Access Compliance Report

Public Rights-of-Way

(Pedestrian Signals)

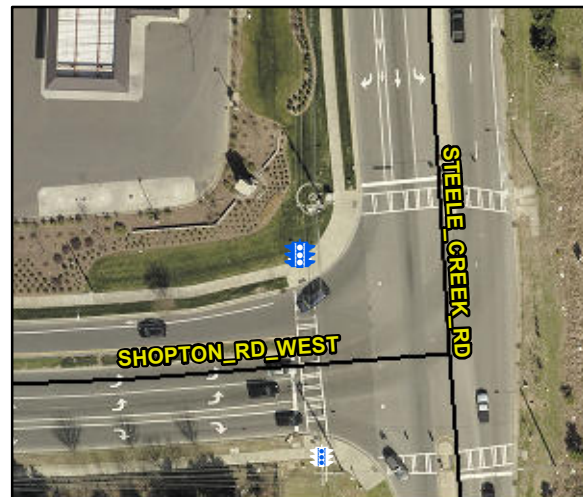
Intersection ID: N/A	Main Street:	Cross Street: N/A	Location: N/A
ADA ID: F65D3865A28E	Signal Type: One Push Button-Non APS	Overall Compliance: No	Severity Score: BTN 1: N/A BTN 2: N/A No BTN: N/A
Codes/Mitigation Info/Possible Solution		Field Measurements/Component Compliance

PROW/ADA: TMUTCD 4e.08, R406.2

Possible Solutions: Replace Signal Push Button With APS Button on New Post. Remove & Relocate Sign.
